<b>Safety Notice</b> Mandatory Action Required	200004	<b>Genie</b> A TEREX BRAND

**Date:** January 29, 2020

**Subject:** Turntable Rotation Bearing Bolts

- 1 Bolts, PN 1256170GT
- 2 Washer, PN 1256182
- 3 Turntable rotation bearing

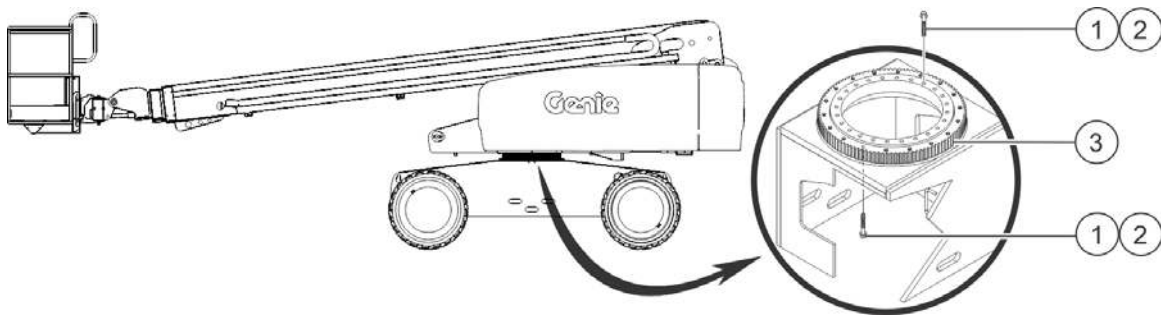
Genie has been notified of three instances where the bottom turntable rotation bearing bolts in the machines referenced above have come loose causing the separation of the turntable from the chassis. **Separation of the turntable from the chassis can result in a machine tip-over or other structural failure.**

- 1 Locate the affected machines referenced above within your fleet.
- 2 **Machines with a year of manufacture 2019 up to the release date of this notice (see Table 1):**
  - Remove the machine from service.
  - Following the instructions starting on page 3, confirm that each turntable bearing bolt is torqued to specification.

- As soon as possible but no later than 30 days from receipt of this notice and following the instructions starting on page 3, confirm that each turntable bearing bolt is torqued to specification.
- 3 Return the machine to service.
  - 4 Fill out and sign the attached completion form and return to Terex AWP Warranty Department or file a warranty claim online to verify that this Safety Notice has been completed.

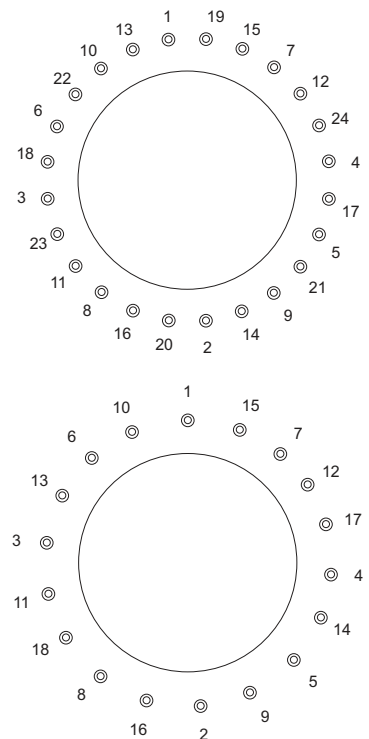
- 1 Raise the (primary) boom and place a safety chock on the lift cylinder rod. Carefully lower the boom until it is 1 inch / 2,5 cm from the lift cylinder safety chock OR support the boom assembly with a suitable lifting device.
- 2 Turn the key switch to the off position.
- 3 Using a star pattern, confirm that each upper turntable rotation bearing bolt (24 X) is torqued in sequence to the specification.

**Torque Specification = 180 ft-lbs / 244 Nm**

- 4 Raise the boom and remove the safety chock OR lifting device.
- 5 Lower the boom to the stowed position.
- 6 Using a star pattern, confirm that each lower turntable rotation bearing bolt (18 X) is torqued in sequence to the specification.
- 7 **Torque Specification = 180 ft-lbs / 244 Nm**
